**PLANNING DIRECTOR'S DEEP LOT SPECIAL PERMIT**  
1231 "I" STREET, SUITE 200, SACRAMENTO, CA 95814

- A. Planning Director's Deep Lot Special Permit to construct a second residential unit on 0.185± partially developed acres in the Standard Single Family (R-1) zone.
- B. Planning Director's Variance to cover 48 percent of the front yard setback with pavement.

**LOCATION:** 7907 39th Avenue

**APPLC. NO. P91-038**

# EXHIBIT - B

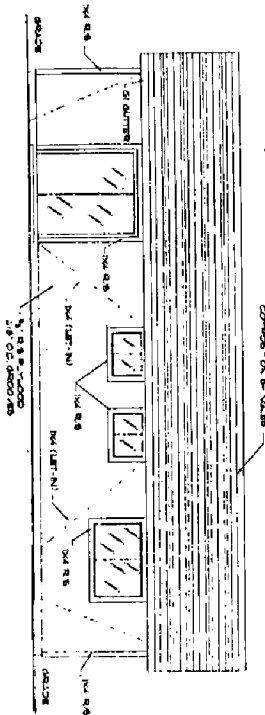
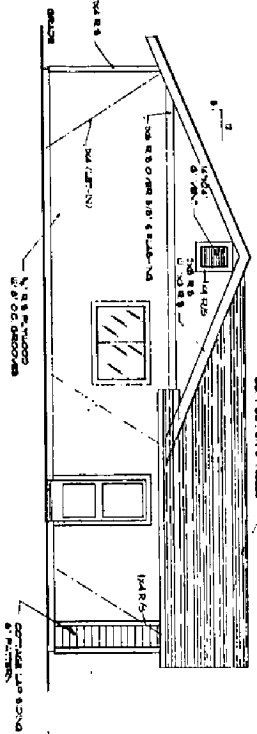
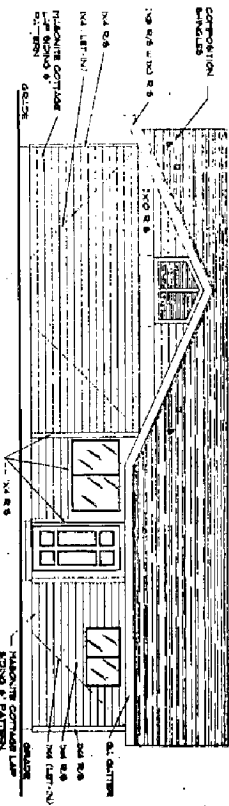
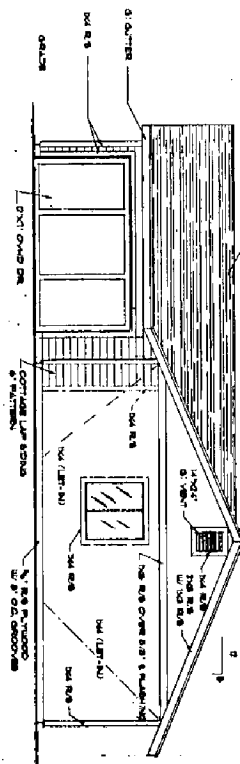
The applicant proposes a single story structure using horizontal masonite cottage lap siding on one side and T-1-11 vertical siding on all other elevations. Staff recommends the horizontal lap siding be used on the south elevation and on the east (front) elevation. The applicant proposes composition shingles for the roof. Staff recommends 25 year laminated dimensional composition shingles for the roof with the color compatible to the proposed house's paint color. Staff also recommends that the paint colors selected compliment the existing dwelling on the site. The garage door should be a metal sectional door painted to match the house and the front door should be a metal six panel door.

- 3. Horizontal lap siding shall be used on the south elevation and on the east elevation. The applicant shall use 25 year laminated dimensional composition shingles for the roof with the color compatible to the house's paint color. The paint colors selected shall compliment the existing dwelling on the site. The garage door shall be a metal sectional door painted to match the house and the front door shall be a metal six panel door. The revised elevations shall be submitted for staff review and approval prior to issuance of building permits.

## SITE PLAN

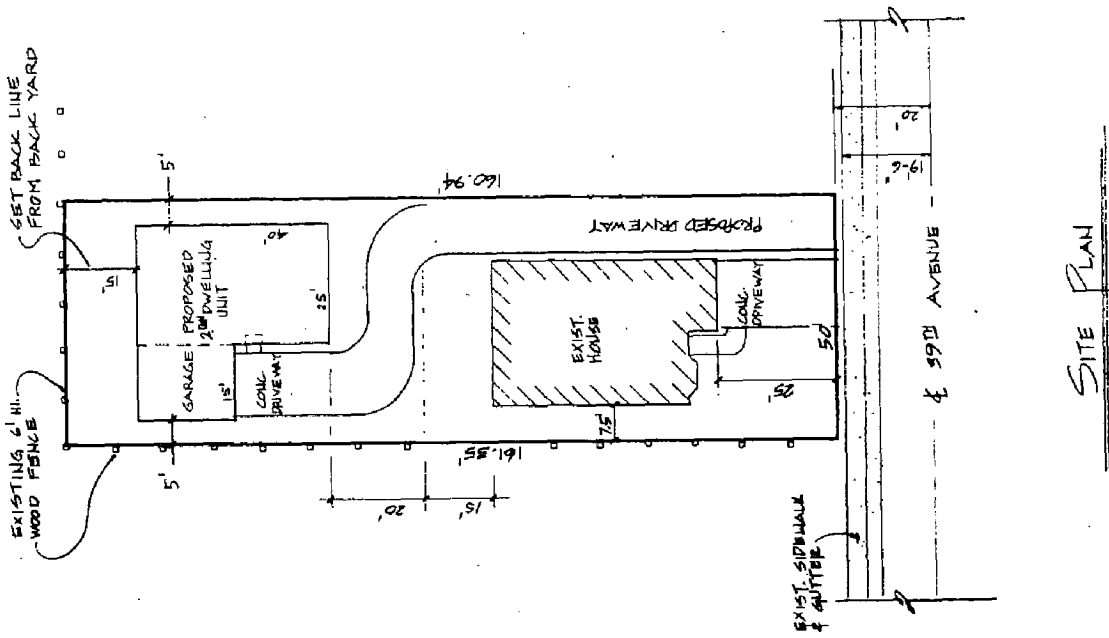
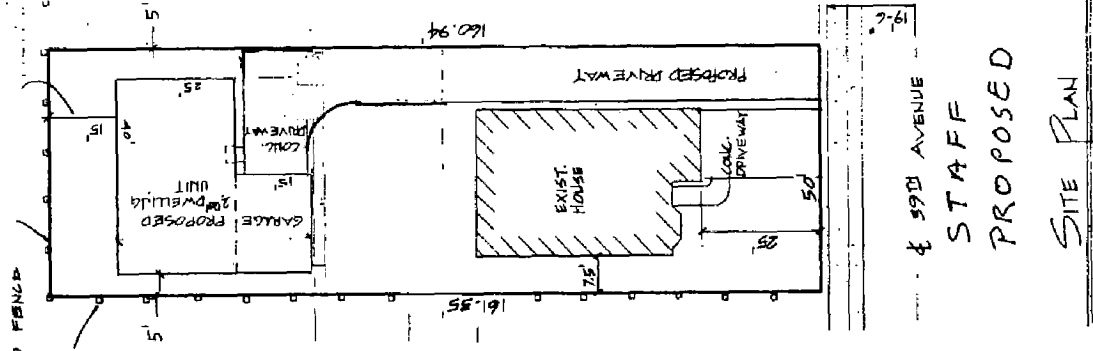
The site plan reflects the proposed second residential unit to the rear (north) of the existing residential unit with the garage located on the west side of the house. The proposed second unit meets all setback requirements. The proposed location of the garage requires an excessive amount of paving to create a driveway for the garage. A very tight "S" turn in the driveway is proposed to access the garage which virtually eliminates a front yard for the second residential unit due to the excessive paving. The proposed floor plan has the front door oriented to the west and the sliding door for the living room opening east into the side yard setback. Staff recommends the applicant rotate the design of the house 90 degrees so the garage entrance faces east in order to reduce the paving in the front yard, orient the front door towards 39th Avenue (south), provide access to the rear yard from the living room, and allow for a front yard for the second unit. Also, the driveway should be redesigned to have a hammerhead which will permit vehicle turn around capability.

The site plan shows an eleven foot wide access way to reach the second unit. The Zoning Ordinance requires a ten foot wide access way for a second unit. Staff recommends the width of the access way be reduced from the proposed eleven feet to ten feet to further reduce the amount of paving required on the lot.

The existing driveway and the proposed access way for the second unit reflected on the site plan totals 625 square feet of pavement in the front yard setback. The Zoning Ordinance states that no more than 40 percent of the front yard setback area may be paved for off-street parking and driveways. The proposed driveways will cover a total of 50 percent of the front yard setback area. Therefore, the applicant must obtain a Planning Director's Variance for the total pavement surface area in the front yard setback area. Reducing the width of the access way to the second unit from eleven to ten feet will only reduce the front yard setback coverage from 50 to 48 percent. The lot is only fifty feet wide with an existing fourteen foot driveway for the front residential unit. Staff has no objections to the Variance as the additional paving is necessary to create an access way to the second unit.

The proposed driveway with two 90 degree turns will be difficult to maneuver. Staff recommends the house plan be flipped to provide the garage on the east side of the property and provide a hammerhead turn around.

- a. The front yard of the existing house will be over 50 percent paved.
- b. The driveway to the proposed house will be difficult to maneuver through, the curves are too tight.
- c. The curved driveway utilizes a large portion of the front yard area for the proposed house. This would work better with a driveway straight into a garage and a hammerhead provided for turn around.

- 1. The applicant shall rotate the design of the house 90 degrees so the garage entrance faces east. The driveway shall be redesigned to provide the proper radius for the curved approach into the garage with a hammerhead to permit a turn around capability. The revised site plan shall be submitted for staff review and approval prior to the issuance of building permits.

- 2. The width of the access way to the second unit shall be reduced from the proposed eleven feet to ten feet and be constructed to meet City paving standards. The submitted revised plans for staff review and approval shall reflect the narrower access way.

- 4. Front yard areas for each unit shall be landscaped with sod, shrubs, and trees, and irrigated with an automatic sprinkler system. The revised site plans shall include the proposed landscaping plans.
